Historic Area Work Permit #652445, construction of addition, garage and other alterations

MONTGOMERY COUNTY HISTORIC PRESERVATION COMMISSION STAFF REPORT

PROPOSAL: Construction of addition, garage and other alterations

4712 CUMBERLAND- HPC MEETING 11/13/2013 - HAWP APPLICATION 4712 CUMBERLAND AVE CHEVY CHASE, MD

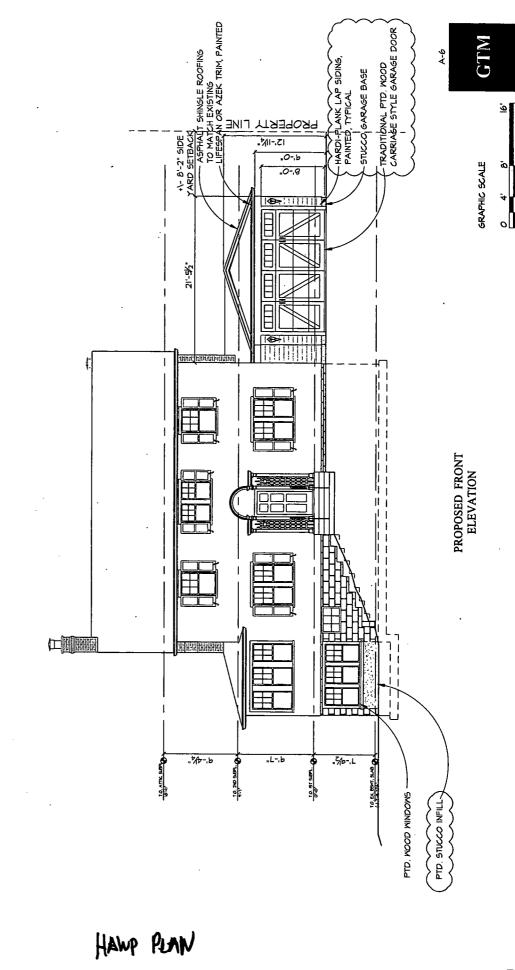
SELECTIVELY DEMO EXISTING AESBESTOS SIDING, INVESTIGATE & REPLICATE/
BESTORE HISTORIC SIDING BENEATH AS NECESSARY. NEW PTD, WOODD TRIM DETAILS TO MATCH EXISTING HISTORIC DETAILS.
